PROJECT *(Name and Address)*
EAST HEIGHTS ELEMENTARY SCHOOL RENOVATION
1776 ADAMS LANE
HENDERSON, KY 42420

CHANGE ORDER NUMBER: 14-2-1
INITIATION DATE: 6/11/2025

Re: PR-01– Electrical Panelboards
Henderson Co. East Heights Elementary School
CMTA Project No. XHER23

CHANGE ORDER

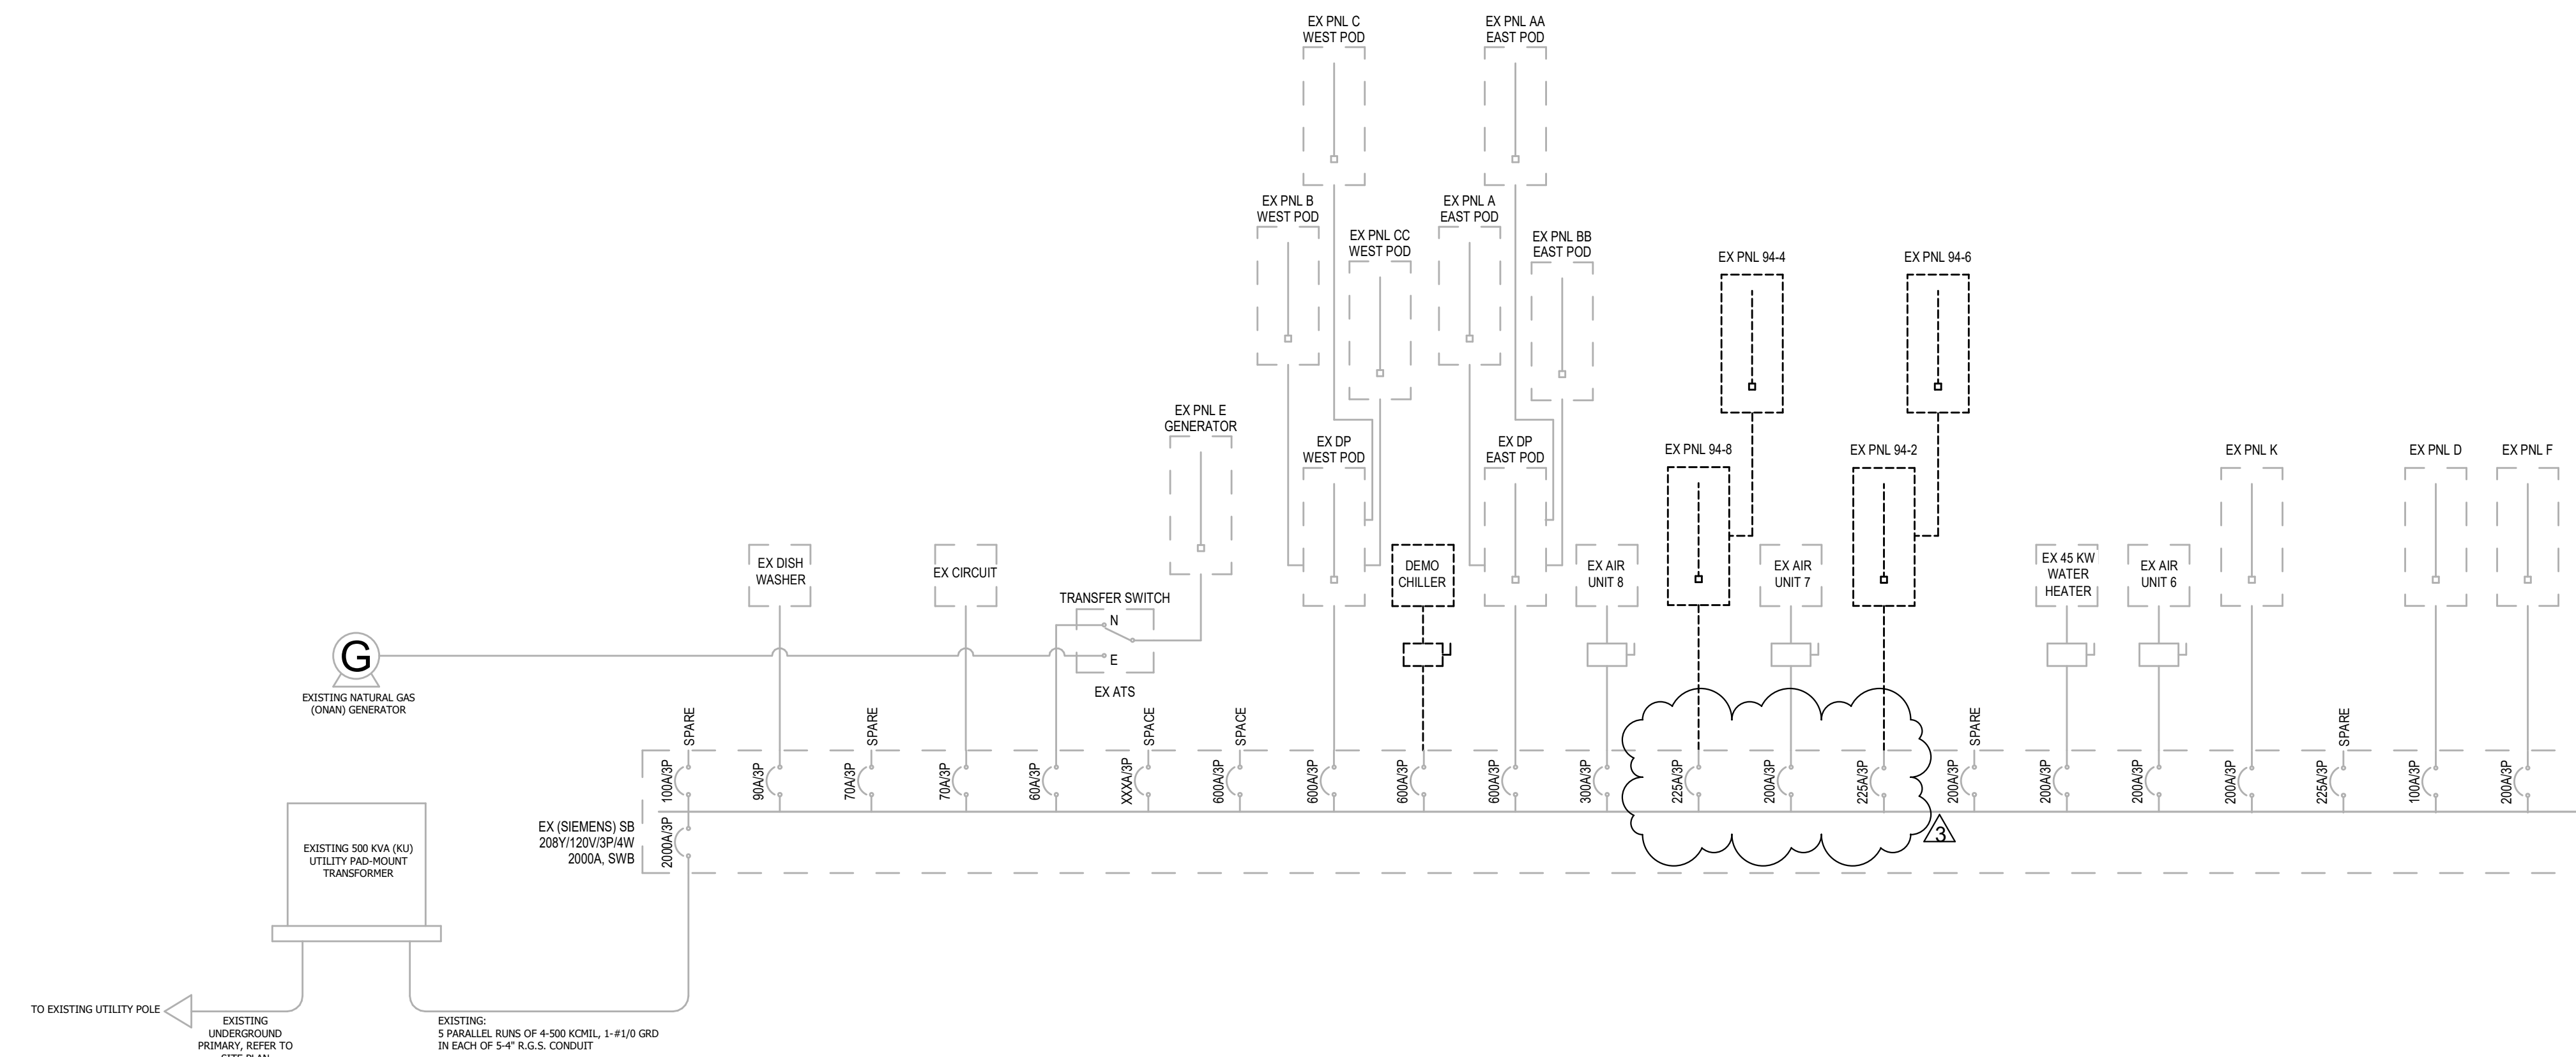
- c. Refer to clouded region. PP5 panel shall be MLO instead of MCB.
2. Refer to Sheet E0.31 – PANEL SCHEDULES:
 - a. Refer to clouded region. MP1 panel shall be MLO instead of MCB.

- b. Refer to clouded region. DP4 distribution panel shall be MLO instead of MCB.
 - c. Refer to clouded region. ELS1 panel shall be 225A MCB instead of 100A MLO. Provide 60A/3P breaker at ELS1 panel for ELS1B instead of 100A/3P breaker. Refer to general note shown on this panel schedule. Refer to clouded changes on One-line diagram for updated wire size and conduit.

- d. Refer to clouded region. ESB1 panel shall be 225A MCB instead of 225A MLO. Refer to general note shown on this panel schedule.
 - i. Refer to One-line diagram and clouded region on Sheet E3.78: Omit SBATS2 transfer switch to panel ESB2. ESB2 panel shall be fed from ESB1 panel and be provided with 60A/3P breaker at ESB1. Refer to One-line diagram for wire size and conduit.

1. ESB2 panel shall be 100A MLO instead of 225A MCB.
 - ii. Refer to One-line diagram: Refer to updated wire size and conduit for panel ESB1B.
3. Refer to Sheet E2.78 – ELECTRICAL ONE-LINE DIAGRAM DEMOLITION – PHASE 2

E2.8

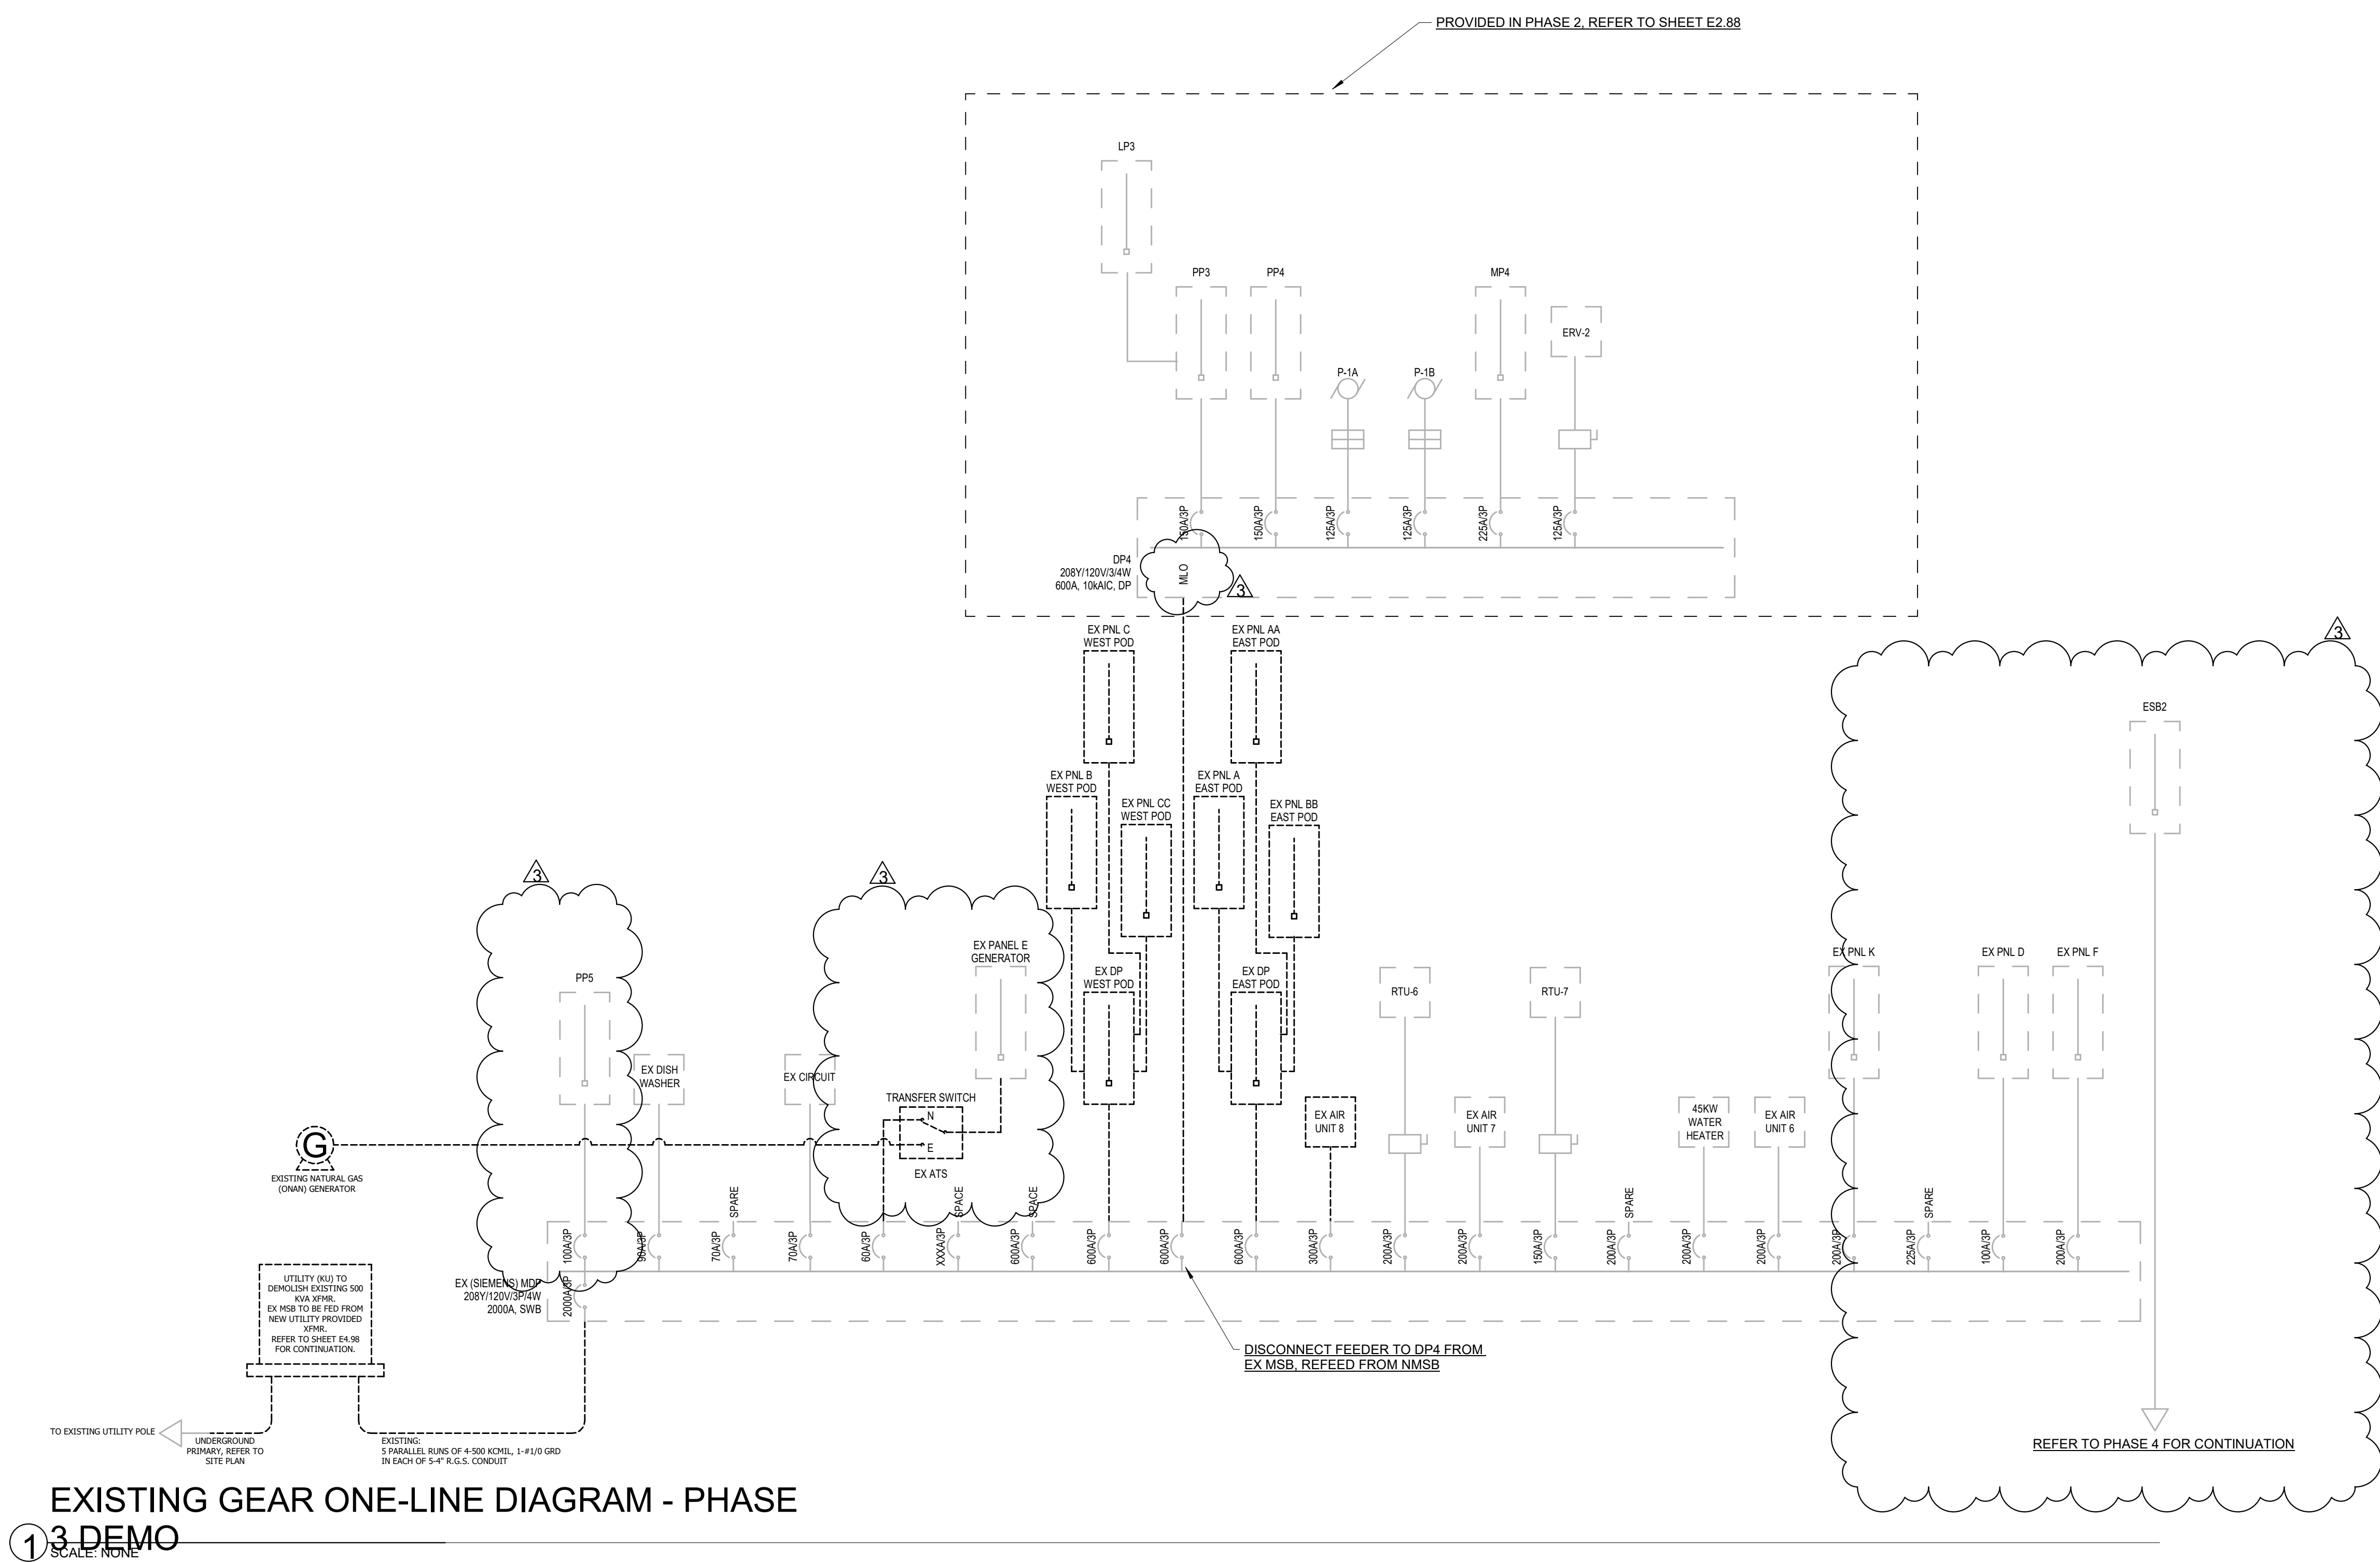
- a. Refer to clouded region for correction.
4. Refer to Sheet E2.88 – NEW ELECTRICAL ONE-LINE DIAGRAM – PHASE 2
 - a. Refer to clouded regions for changes:

- i. Provide 60A/3P at the new NMDP for both LP1 and LP2 instead of 100A/3P. Refer to change/decrease in wire size as well.
 - ii. Provide DP4 with MLO instead of MCB.

- iii. PP5 is now shown as being fed from EX (SIEMENS) MDP. Utilize existing 100A/3P spare breaker at the panel.
- iv. LP3 shown with change/decrease in wire size.

- v. Per Item #2(d)(i): ESB2 panel fed from ESB1 panel.
- b. For Generator panels:
 - i. General note: Refer to changes in wire sizes.
 - ii. Provide two (2) 225A/3P electronic trip breakers on the generator instead of four(4) 100A/3P breakers on the generator: One for ELS1 branch and the other for ESB1 branch.

- iii. Docking Station shall be 225A/3P instead of 100A/3P.
 - iv. LSATS transfer switch shall be 225A/4P instead of 100A/4P.
 - v. SBATS transfer switch shall be 225A/4P instead of 100A/4P.

- vi. Refer to additional information for the provision of dedicated load center for generator circuits (battery charger, heater, etc.).
- 5. Refer to Sheet E3.11 – ELECTRICAL DEMOLITION PLAN – PHASE 3 – AREA B
